# Core Path Report for C284 Clynder High Road to Peninsula Path

## 2. Summary of Representations Received

Proposed amendment to C284 shown in green and purple and extending to picnic bench and trig point at Clach MacKenny

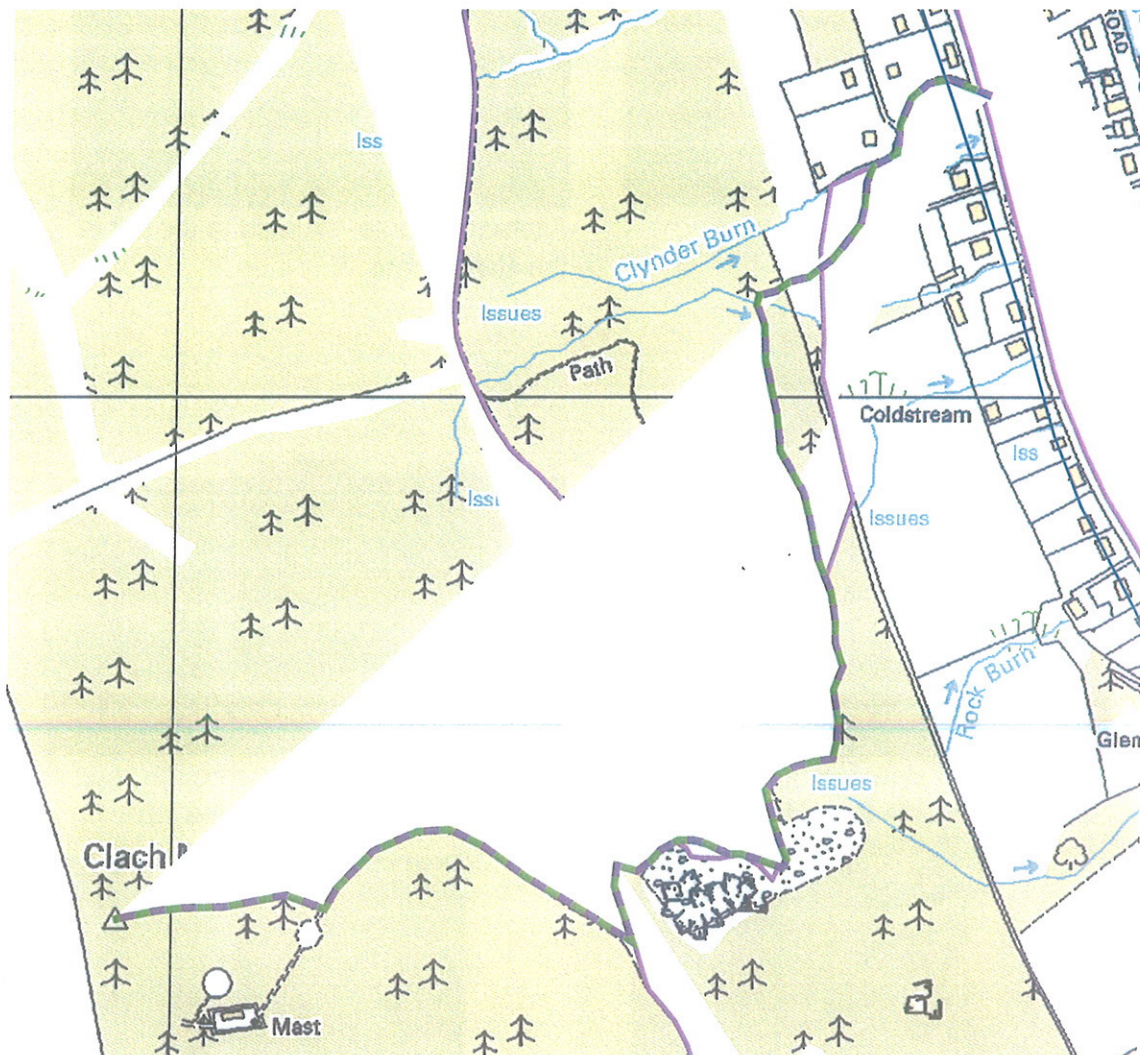
The supporter of this path has proposed extending the route out to the picnic bench and trig point. This has a lot of merit since a vehicular access road exists to the radio mast; and a constructed path exists to the picnic bench and trig point. The site offers good vistas of the peninsular.

The path should extend to Clach MacKenny.

C284	Support	This should be extended to the picnic table on the top of Clach MacKenny., which is a popular destination.
------	---------	--

**Conclusions** – I am of the view that this path should be designated as a Core Path along with the proposed extension to the summit of Clack MacKenny. The path provides a link between the village of Clynder and the extensive area of forestry to the west as well as the summit of the hill with its views of the peninsula and surrounding sea lochs, hills and the Clyde Estuary.

Therefore I recommend that the Council continues to promote C284 as a Core Path.
